VEHICLE SAFETY DEFECT SERVICE BULLETIN
Recall Campaign 07V582000 US Units
Recall Campaign 07-406 CN Units
Monaco File R07039

Re: Safety Recall – Exposed Terminal Post

RECALL
USA 07V582000
Canada 07- 406
EXPOSED BATTERY TERMINAL FRONT RUN BOX

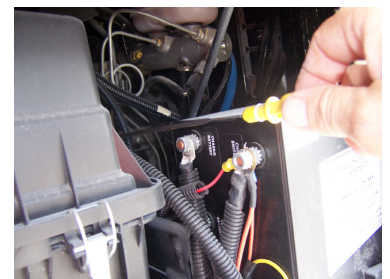
1. Park unit and turn engine off. Open the front hood and locate the Front 12V Distribution Panel.
2. On the side of the panel, locate the 4 - 12V Wire Terminals. If the terminals are exposed, (Picture A & B) proceed with repair instructions.
3. If the unit has Red Rubber Insulated Boot Covers installed on all four wire terminals, (Picture C) proceed with repair instructions.

picture A

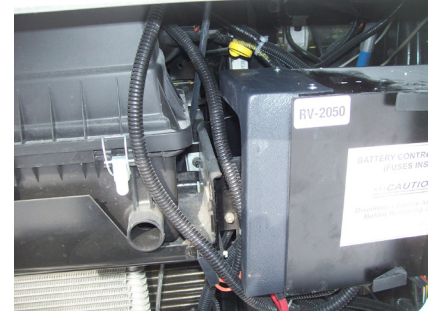
Monaco determined that when these motorhomes were designed, the front run panel had an exposed terminal post on its side allowing the oil dipstick on the Ford chassis units only to potentially make contact when checking oil level. The location of the exposed terminal post is under the front engine access hood. When the oil level is checked, it may be possible for the dipstick to contact the exposed wire terminal stud. If other end of dipstick is grounded, this could result in an electrical shock or a spark that could create a fire. As a precautionary measure, Monaco Coach Corporation has elected to perform this voluntary safety recall campaign.

To install the ABS cover over the battery terminal posts of the front 12Volt Distribution Panel; preventing possible electrical shock or a spark that could result in fire.

3. Take a large screwdriver or prybar and spread open the two angled slots in the left upper and lower corners of the electrical box (Picture D).
4. Install the ABS Cover into the bottom slot first and then tuck the top into the top slot. Push the side back between the wires and the Air Filter Mount.
5. Line up the rear pre-drilled hole in the top of the electrical box with the rear hole in the ABS cover and install one of the #8-1/2" Tek Screws. Push the front of the cover over and install the second screw through the front pre-drilled hole in the ABS Cover and secure into the metal box.
6. Reinstall the panel lid and re-latch (Picture E).
7. Turn Battery Disconnects back on and verify that the coach and chassis functions are OK.
